Recall for Replacement: GRIGRI 2

Concerns all GRIGRI 2's (D14 20, D14 2G, D14 2B)
with the first five digits of the serial number between 10326 and 11136

Figure 1

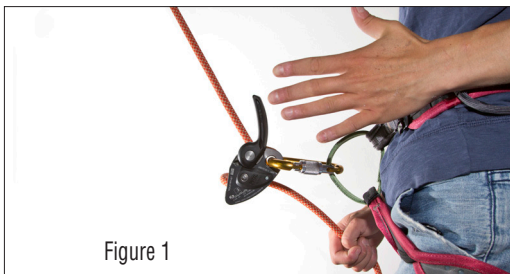
Petzl has discovered that exerting excessive force on the fully extended handle of the GRIGRI 2 can cause internal damage, such that the GRIGRI 2 handle may become stuck in the open position, as pictured in Figure 1 below.

When the handle is stuck in the position shown in Figure 1, the assisted braking function is disabled. A damaged GRIGRI 2 in this configuration will function similarly to a manual belay device (e.g. tube-style device).

When using a damaged GRIGRI 2 with the handle stuck in the open position, failure to control the braking side of the rope will dramatically increase the risk of an uncontrolled descent, possibly resulting in injury or death. A GRIGRI 2 with a damaged handle must be immediately retired from service.

- Ask users to immediately stop using all GRIGRI 2's with the first five digits of the serial number between 10326 and 11136.
- **Recall all affected GRIGRI 2's and replace with new, revised versions.** Petzl will pay for all shipping costs to complete this replacement.
- Increase the mechanical strength of the handle on all GRIGRI 2's from serial number 11137 onward.
- Begin shipping replacement GRIGRI 2's immediately. Users will receive replacements in the same order they return their old units to Petzl.
